Johannes Specht (Self), Individual Contribution

This state diagram is an abstract proposal for structuring the next version of Figure 17-3 from IEEE P802.1ASdm/D1.0.

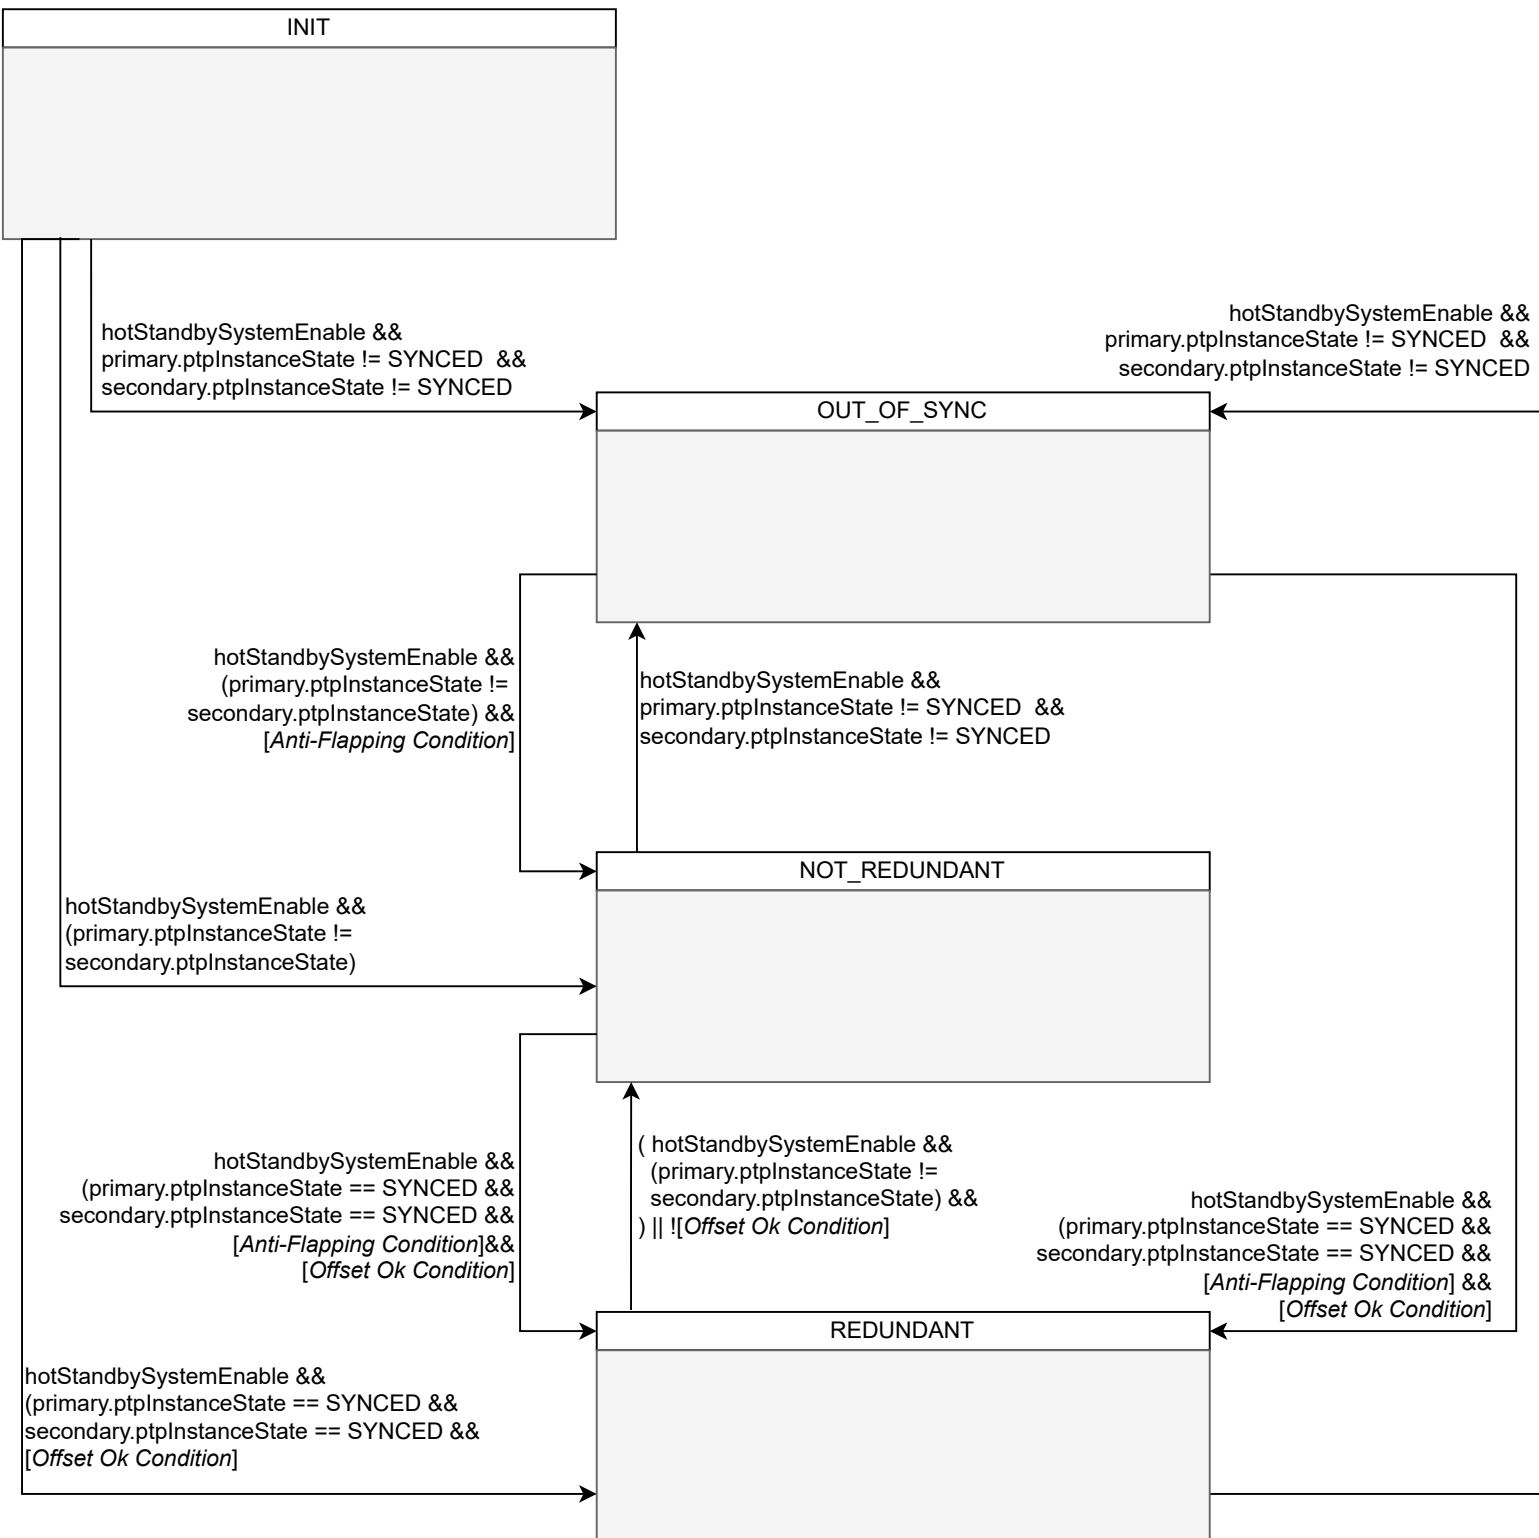
It is an early version and it is abstract in the sense that the state actions are not shown in detail (grey), and some conditions on transitions are partially given in prose (and in brackets). The authors intent is to illustrate a conservative approach for fault-tolerance in the given context, and simplify the layout of the diagram.

[Offset Ok Condition]: The offset between primary and secondary time is low enough.

[Anti-Flapping Condition]: A local timeout expired. The timeout is used to prevent too fast transitions between two states ("toggling").
